*Proceedings of the Madras Government, Public Works Department,
21st September 1864.*

Passing orders on the report of the Sanitary Commissioners, containing their opinion on the plans and estimates of the proposed Lawrence Asylum at Ootacamund, Coimbatore District, with reference to their fulfilment of sanitary requirements, and, generally, with reference to the cost of the building. } (Here enter 9th September 1864, No. 263.)

No. 39. Read the following letter from the Honorable R. S. ELLIS, President, Sanitary Commission, Madras; to Honorable A. J. ARBUTHNOT, Chief Secretary to Government, Fort Saint George, Madras, dated 20th July 1864, No. 201.

2. The plans of the proposed Male and Female Lawrence Asylums have been carefully examined by this Commission, and appear in most respects to meet the requirements of the institutions.

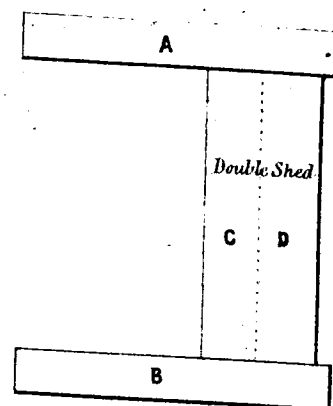
Proposed Plan.—6. It is also to be observed that the sheds of the long sides of

the quadrangle are left open on the inner side facing the Gymnasium Court-yard. This will render them practically of little use in the monsoon, and could be easily remedied by altering the present arrangement of the buildings as shown in the margin; blocks A and B being sheds enclosed on both sides, and C and D on the outer side only.

Alteration suggested.—7. I would suggest that blocks C and D should be approximated and made to form one double shed, closed at both outsides, and that the Gymnasium should be continued in the space enclosed on three sides by the sheds thus re-arranged.

This would in no degree diminish the actual superficial extent of covered ground, and would make it available for use at all seasons, while the depth of this double shed (42-8) would allow of its being more useful as a play-room than two rooms of open shed of the same length. A slight diminution of expense would also be effected.

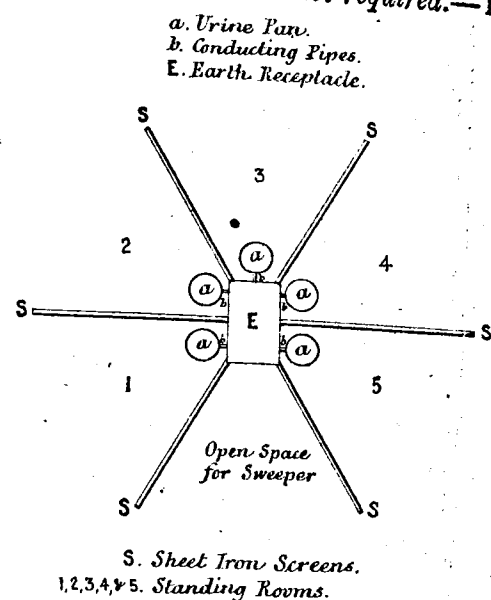
Suggested improvement in those for the Male Asylum.—11. The urinals for males might without difficulty be constructed on the same principle as those manufactured by Mr. Jennings, shown at page 93 of the "Report of the Commission appointed for improving the Sanitary condition of Barracks and Hospitals" (1863).

Three or four of these might be introduced into the building now designed as a privy, and the urinals might be got rid of altogether as distinct buildings, and a further sum of Rupees 2944 thus saved.

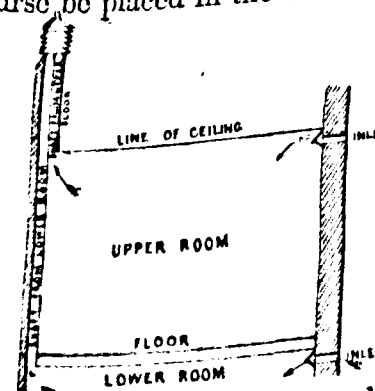
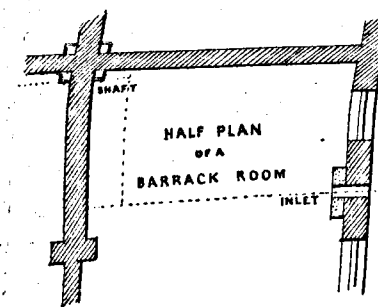
Drinking Fountains required.—The arrangement of the school-rooms appears good, but we are struck with the want of a drinking fountain either in or close to these apartments. Some such provision should be made here and in the sleeping apartments and dining-rooms.

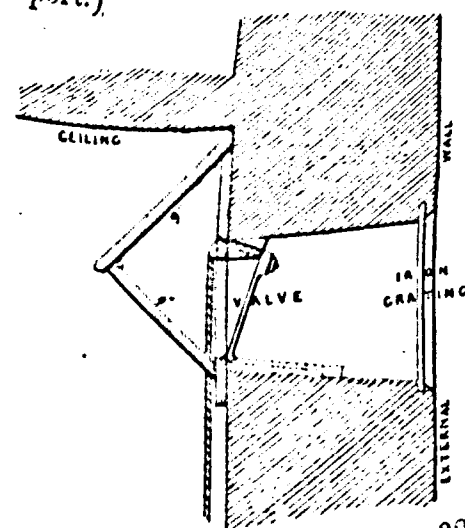
Improvements suggested.—29. We are of opinion that the ventilation provided for in the upper rooms is sufficient; but in the lower rooms, instead of having ventilating shafts upon both sides, we strongly recommend the adoption of the arrangement suggested by the "Commission appointed in England for improving the Sanitary condition of Barracks and Hospitals."

30. This arrangement is shown at page 76 of their Report. The inlets should of course be placed in the outer walls near the ceiling; thus:

and we recommend that they should be of the section here shown—(Page 75 of same Report.)

We further recommend that the "inlets" should not be placed immediately opposite the ventilating shafts, but that they should be respectively placed between every two adjacent ventilating shafts at points equidistant from both.
